**(1) County Council Consultation Draft Masterplan for Sniperley Park
(2) Healthy Active Travel Connectivity Plan**

The City of Durham Trust warmly welcomes the opportunity to comment on the County Council's Consultation Draft Masterplan for Sniperley Park (CDP Site H5) and the associated Healthy Active Travel Connectivity Plan. (We note that the Cabinet resolved to put both documents out for consultation but only the Masterplan appears on the online consultation portal and therefore many people will be unaware of the consultation on the Healthy Active Travel Connectivity Plan.)

CONSULTATION DRAFT MASTERPLAN FOR SNIPERLEY PARK

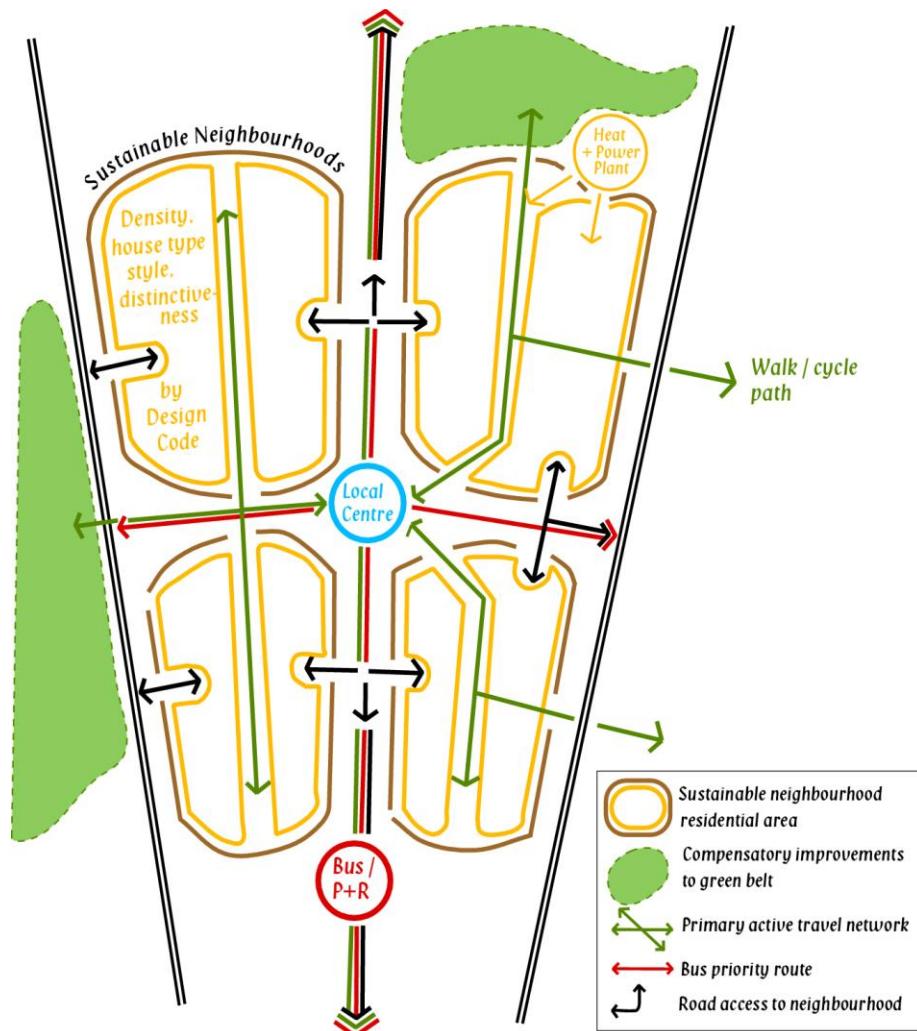
The most important context as yet unresolved is the spatial relationship between the residential neighbourhoods and movement and access. It is not for the Trust to prescribe in any detail what that should be, but to demonstrate the general principles that could be pursued into a practical spatial reality. The schematic diagram below seeks to demonstrate those principles in terms of the sustainable transport hierarchy and other infrastructure elements.

The sketch sets out elements of infrastructure that are required to guide subsequent planning stages in the delivery of coordinated sustainable development. It is indicative only and does not seek to represent the reality of the Sniperley site. It is based on the need for a design-led approach to neighbourhood units within the context set by the landscape and green infrastructure. It shows the application of the sustainable transport hierarchy which will be the best blend of separate and shared space for movement including segregated walking and cycling paths, a bus priority route and shared sections for local traffic distribution. A Spatial Plan based on such principles could also show more detail of community facilities and their relationship to the access and movement facilities.

Figure 4.5 North-western corridor proposals

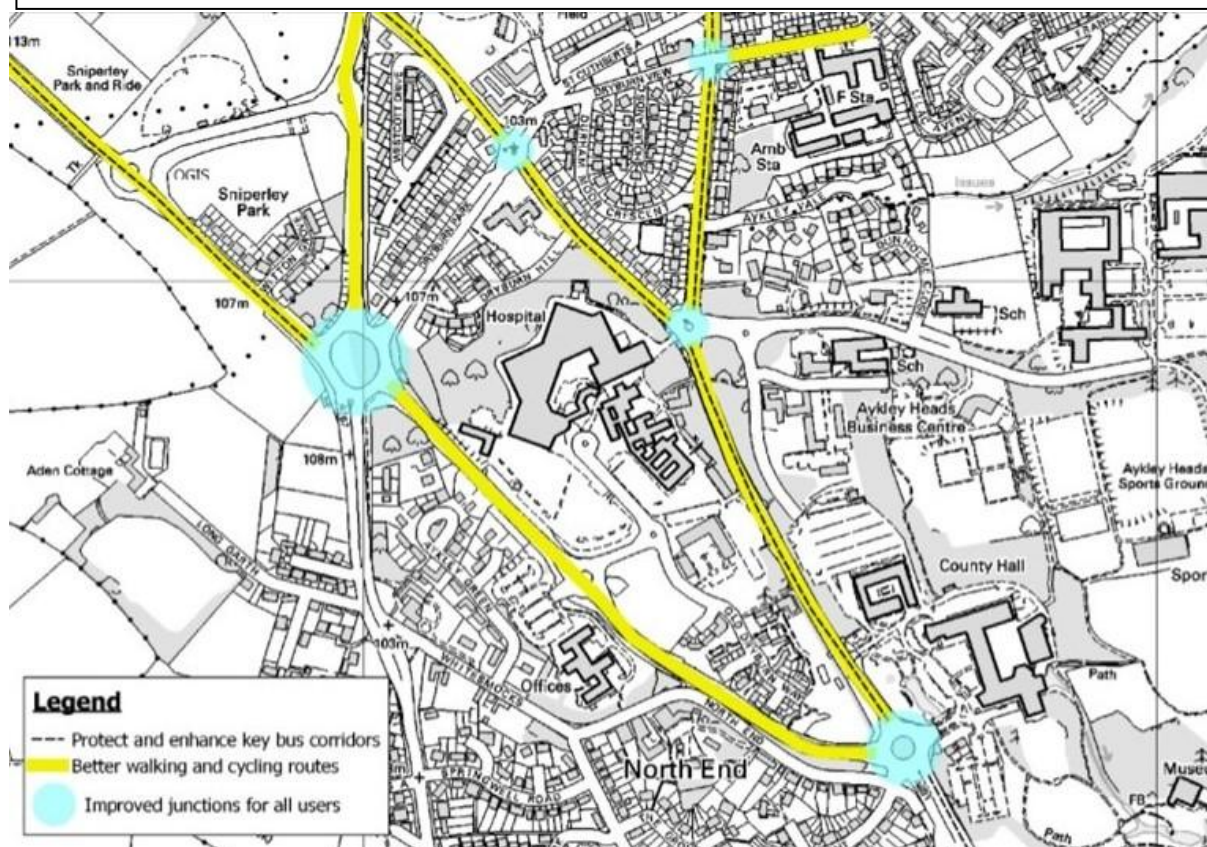
The Durham City Sustainable Transport Delivery Plan (which supports Policy 22) identifies many of the routes and the measures which are required in the *“north-western corridor”* (see Figure 4.5 below). The provision for buses and cycling is highlighted as a priority, including *“the large roundabout junctions in the area, which present intimidating and potentially hazardous conditions for cycling as they are presently configured”*. Safer road crossings for pedestrians are also identified as necessary.

Policy 21 refers to the Local Cycling and Walking Infrastructure Plan for Durham City, which identifies the main cycle network to be developed as well as pedestrian routes to be enhanced. We have highlighted in yellow on the diagram on the next page those routes which would help deliver the connections to the main facilities we have identified.

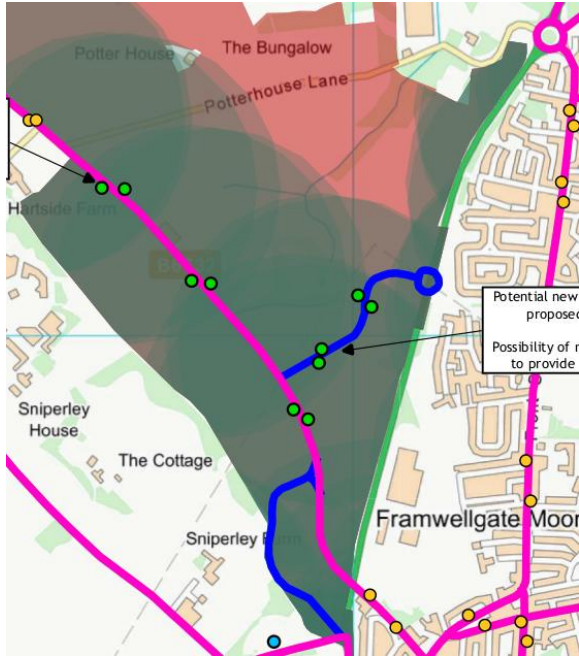
The Masterplan has not demonstrated clearly that the proposed road layout can achieve such distances for all parts of the development. To do this the likely bus service frequencies on each road must be identified. That will determine the appropriate walking distance from bus stops on those roads. The placing of the bus stops can then be determined: on a road with a lower frequency service they may need to be closer together, but a balance has to be struck to avoid the bus having to stop too often. This placement needs to be done in conjunction with the design of the residential street and path network to ensure that the walking routes are sufficiently direct. Actual distances, rather than radii, need to be considered.

As it says in *Manual for Streets*, para 6.5.9, it is “*essential to consider the siting of public transport stops and related pedestrian desire lines at an early stage of design. Close co-operation is required between public transport operators, the local authorities and the developer*”.
